ISSUE RESOLUTION STATUS REPORT

KEY TECHNICAL ISSUE: REPOSITORY DESIGN AND THERMAL-MECHANICAL EFFECTS

**Division of Waste Management
Office of Nuclear Material Safety and Safeguards
U.S. Nuclear Regulatory Commission**

Revision 3

Figure 15. Examples of (a) a regular fracture pattern and (b) an irregular fracture pattern

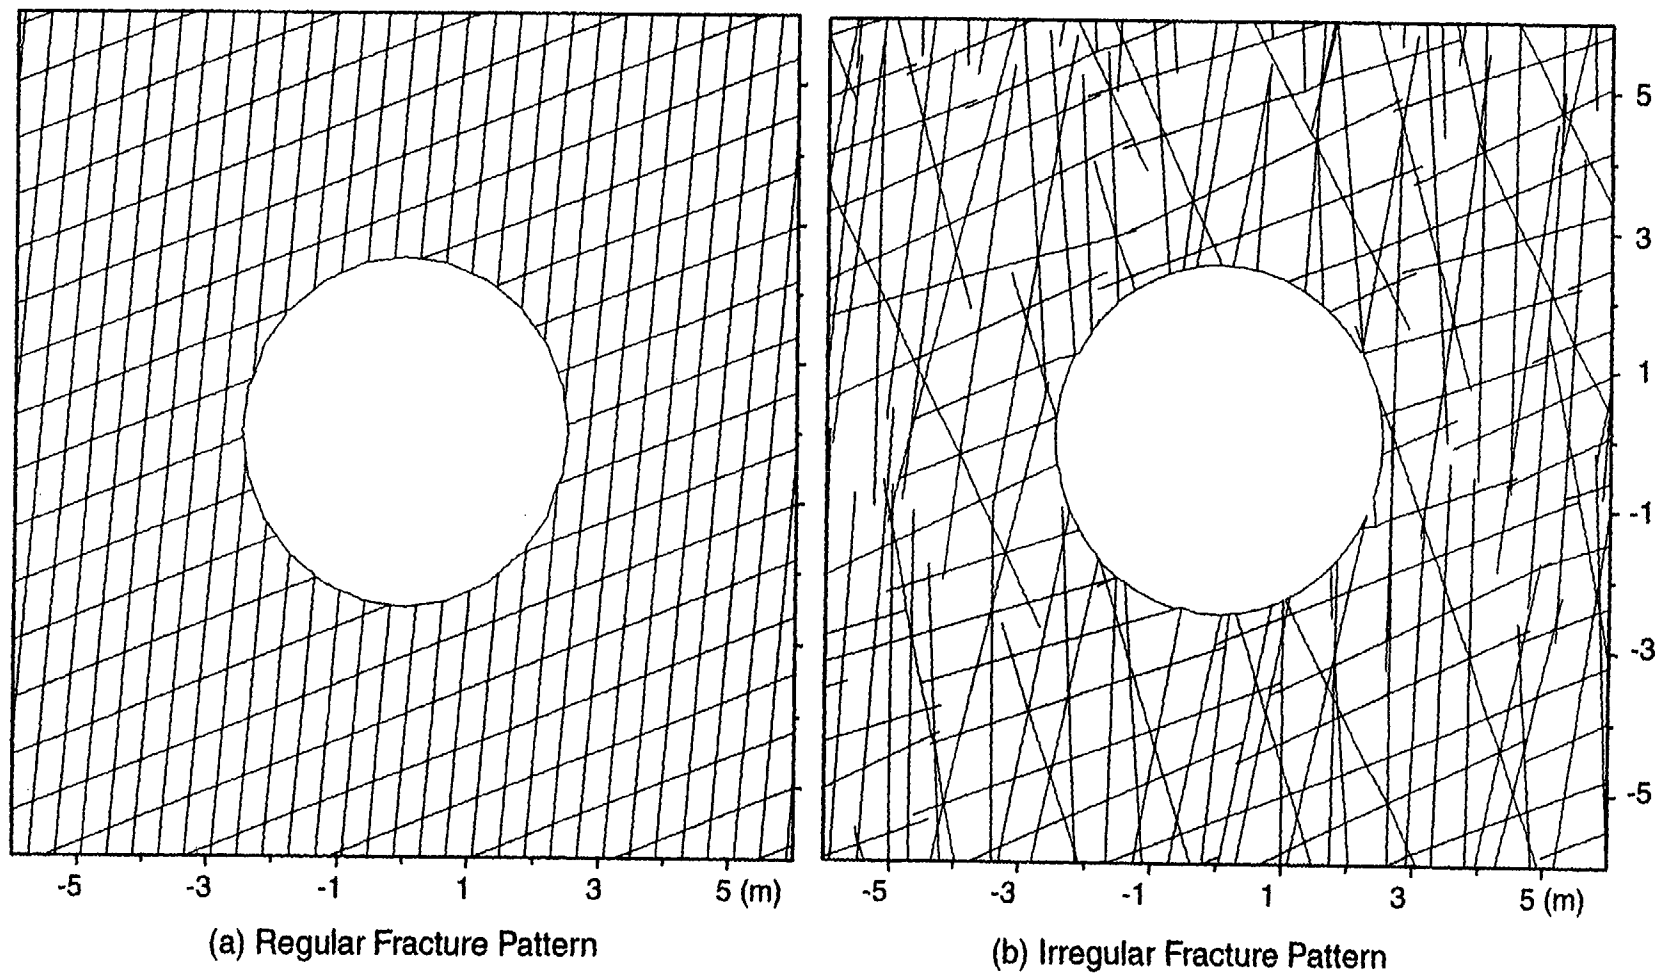
Dynamic modeling results (Chen, 1998; 1999) show that of all these factors, fracture pattern may have the most significant effect on rockfall. Therefore, analyses using a regular fracture pattern such as the one shown in Figure 16 may not be conservative. An ongoing effort at CNWRA is to simulate fracture network patterns representative of the *in situ* conditions based on mapping and scanline data from the ESF and Cross Drift. Future dynamic analyses will incorporate more realistic fracture patterns and recent changes in DOE repository design.

Figure 19. Damage level versus peak ground velocity

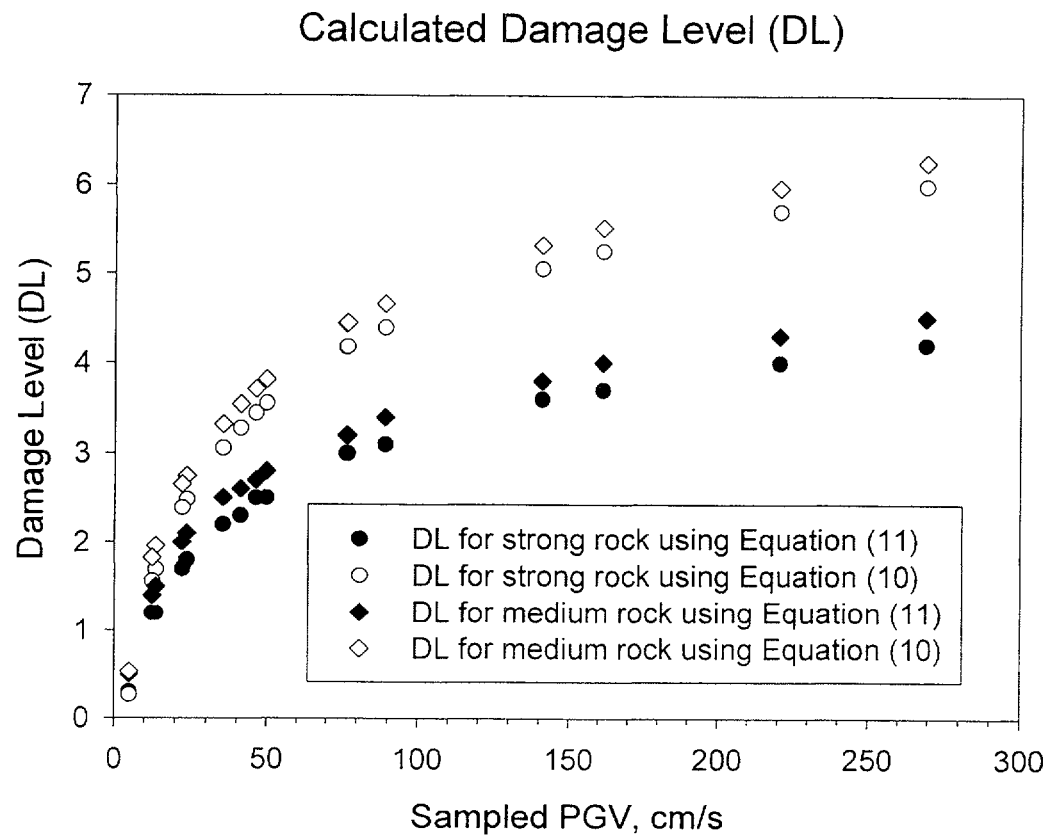
Figure 19 graphically shows the difference of DL values calculated for various peak ground velocity (PGVs) using these two equations. The calculated DL value is about 40 percent smaller for strong rock and about 30 percent smaller for the medium rock if Eq. (11) is used. It is not clear which equation was intended to be used in the TBD. If Eq. (11) is the correct equation, DOE needs to provide justification. If the use of Eq. (11) is a mistake, this mistake needs to be corrected and the rockfall effect on WP damage reevaluated.
